NOTICE OF VIOLATION

INSPECTION REPORT

Electrical Corporation:	San Diego Gas & Electric Company
Report Number:	CAD_SDGE_LOK_20241105_1438
Inspector:	Lovepreet Kaur
WMP Year Inspected:	2024
Quarterly Data Report (QDR) Referenced:	Quarter 2 (Q2)
Inspection Selection:	Energy Safety viewed the contents of the Q2 QDR and performed an analysis that resulted in the selection of the WMP initiatives and locations referenced in this report.
Relevant WMP Initiative(s):	8.1.2.10.1 Avian Protection Program (WMP.972)
Date of inspection:	November 5, 2024
City and/or County of Inspection:	Bonsall, San Diego County
Inspection Purpose:	Assess the accuracy of SDG&E’s QDR data, completeness of its work, compliance with WMP requirements, and compliance with its protocols.

Violation 1

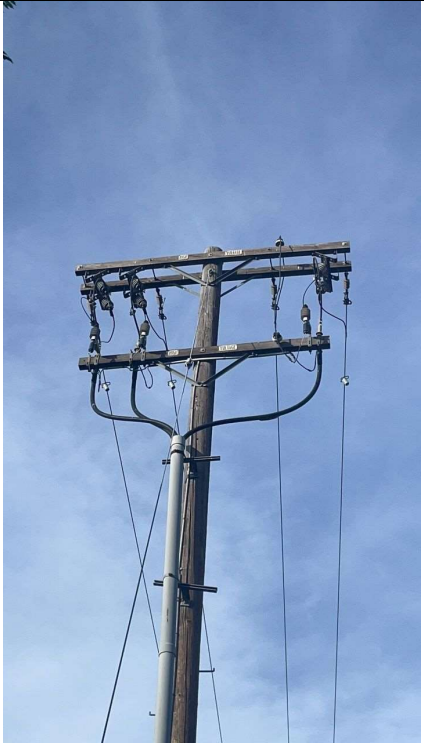
On Pole ID P611012, Grid Hardening ID 530000338845-P611012 at 5768-5768 Camino del Cielo, Bonsall, CA, 92003, USA, 33.29414100199491, -117.20869477988714, the inspector observed that avian protection covers were not installed. The inspector's observation is documented in Violation 1 photographs, which are attachments to this report. Photo numbers Item1G1mg1, Item1G1mg2, Item1IA11mg1, and Item1IA11mg2 depict missing avian protection covers.

1. The reported location provided by SDG&E indicated that work on the Avian Protection Program (WMP.972, 2023 WMP Initiative 8.1.2.10.1) was reported as completed.
2. Avian protection covers were not installed at the location.

Item1IA1mg1: No avian covers observed

Item1IA1mg2: No avian covers observed
